NOTICE OF DETERMINATION

Project Name: SP94-002, REZ 94-007, LOG NO. 94-8-30, CHAMPAGNE GARDENS SPECIFIC PLAN

**FINAL
ENVIRONMENTAL IMPACT REPORT**
for
**CHAMPAGNE GARDENS
SPECIFIC PLAN**
DPLU Case # SP94-002, REZ 94-007
Environmental Log No. 94-8-30
SCH# 95101055

Figure 10

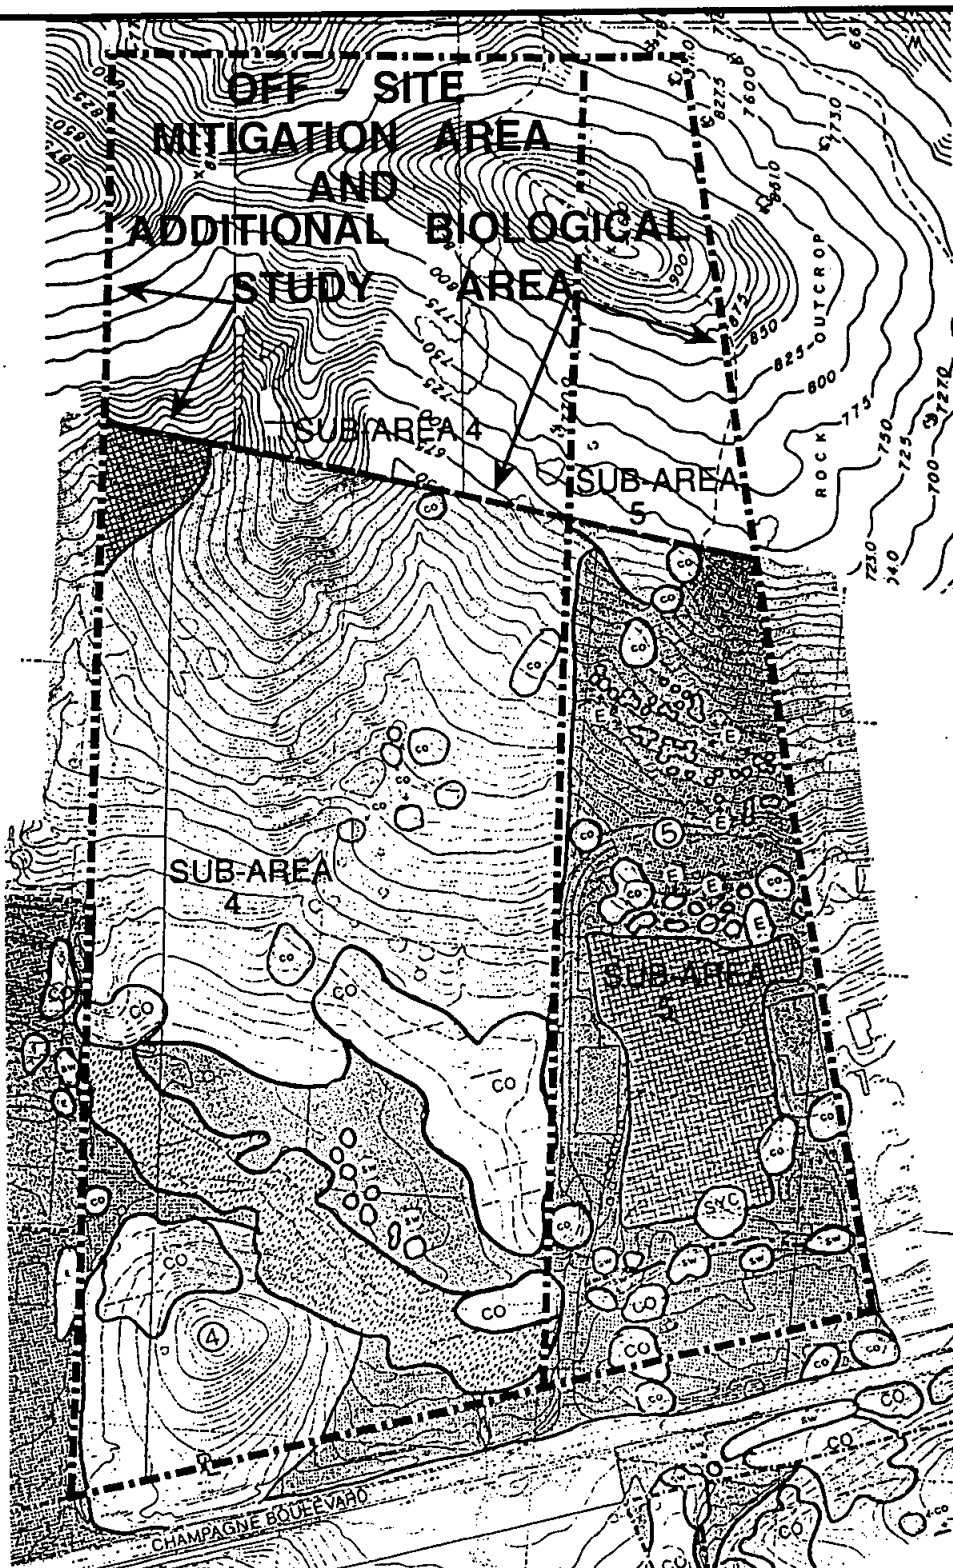
A-7 The draft EIR states that 11.36 acres of CSS will be preserved on adjacent properties under the same ownership. It is the Service's understanding that this is the area mapped as "Additional Biological Study Area" in Figure 10. Please clearly label the offsite mitigation area in the final EIR.

Response -A-7 The comment is acknowledged. The Additional Biological Study Area shown in Figure 10 is the offsite CSS area to be preserved in open space. The figure has been modified to include the requested label.
